Consideration of Comments on 1st Draft of Relay Loadability

The Relay Loadability Standard Drafting Team thanks all commenters who submitted comments on the 1st of the Relay Loadability standard. This standard was posted for a 45-day public comment period from August 16 through September 29, 2006. The Relay Loadability Standard Drafting Team asked stakeholders to provide feedback on the standard through a special standard Comment Form. There were 36 sets of comments, including comments from more than 100 different people from more than 50 companies representing 6 of the 9 Industry Segments as shown in the table on the following pages.

Comments on NERC Line Loadability Standard PRC-023 Reference

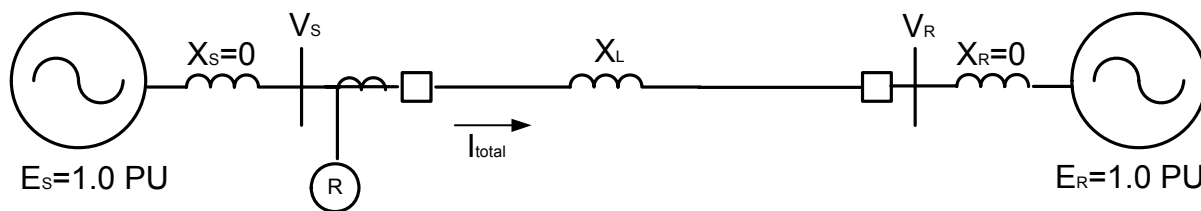
Most WECC members are well aware of the problem of setting zone 2 or zone 3 distance relays on long transmission lines with enough reach to adequately protect the line without violating NERC recommendation 8A. The problem arises because the thermal current limit of a line is independent of the lines length and does not change for a given conductor size no matter how long it is. The impedance of the line, however, increases with the lines length. As the line length and impedance increases, the reach of the distance relays that protect the line must also increase to provide adequate protection, until at some point the relay setting would operate for the maximum thermal current. This creates the dilemma of how to protect such a long line without limiting its load carrying ability.

On the other hand, as the line length and impedance increases, the ability to transfer power across the line diminishes until a point is reached where the maximum possible power transfer is less than the rated thermal power transfer limit. Using this diminished power transfer capability instead of the thermal limit as the basis of setting the reach of the distance relays should allow for a longer relay reach that will hopefully provide adequate protection for the line.

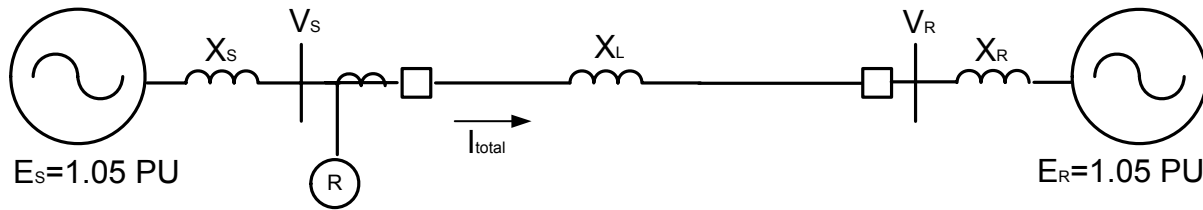
The maximum allowable reach for a mho characteristic relay at the line angle of 90° is:

So, the use of a 30° power factor angle as recommended in R1.3.1 offsets the safety margins that were applied and allows a slightly longer distance relay reach of 104.5% of the line impedance. This is not enough reach for a zone 2 relay to provide adequate protection for the line. The maximum power transfer approach, as used in R1.3.1, is useless in justifying adequate zone 2 settings for long lines!

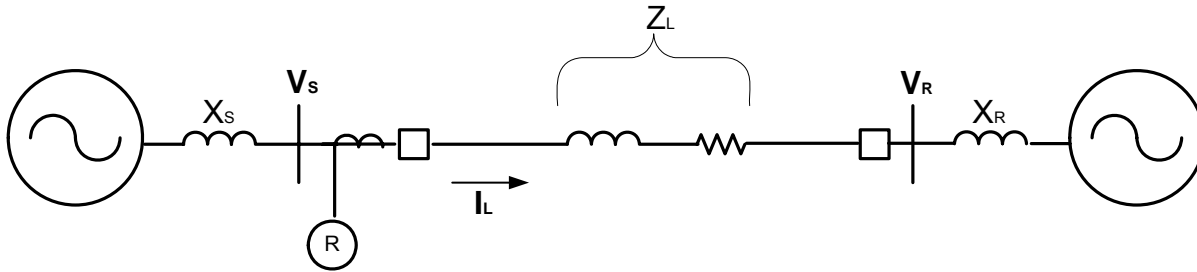
This shows that the maximum allowable reach of a mho characteristic relay at the line angle is approximately equal to $(X_S + X_R + X_L)$. This method will only allow a mho characteristic relay to overreach the line impedance by the same percentage that $X_S + X_R$ is to the line impedance X_L .

In order to justify setting a zone 2 relay at the standard 125% of the line impedance with this method, $X_S + X_R$ must equal 25% of X_L . For many long lines the source impedance at the terminals will not equal 25% of the line impedance and this method will not justify a mho characteristic reach that provides adequate line protection.

As in R1.3.1, R1.3.2 applies the relay reach at a power factor angle of 30° instead of the correct angle of 45° . Using 45° results in even less allowable relay reach.
